Service Note		
Product	Description:	Service note no.
Lucia	Amplifier channels swapped	SNo-T201

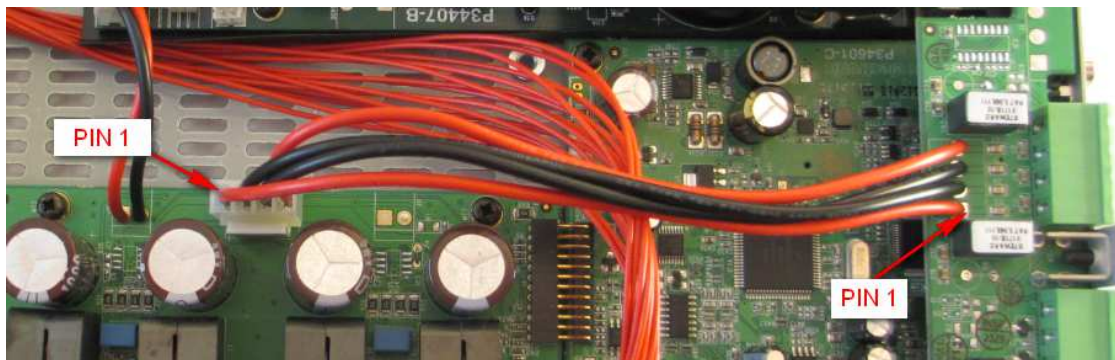
We have seen a few incidents where the amplifier channels in a Lucia product have been swapped. That means Channel 1 by accident is connected to Output 2 and vice versa.

To fix this error the 4 wires have to be relocated as shown below:

The correct mounting of the wires. Pin 1 to pin 1. 2 to 2, 3 to 3 and 4 to 4. That can be done either by unsoldering the wires for relocation or to unplug and replace in the connector.
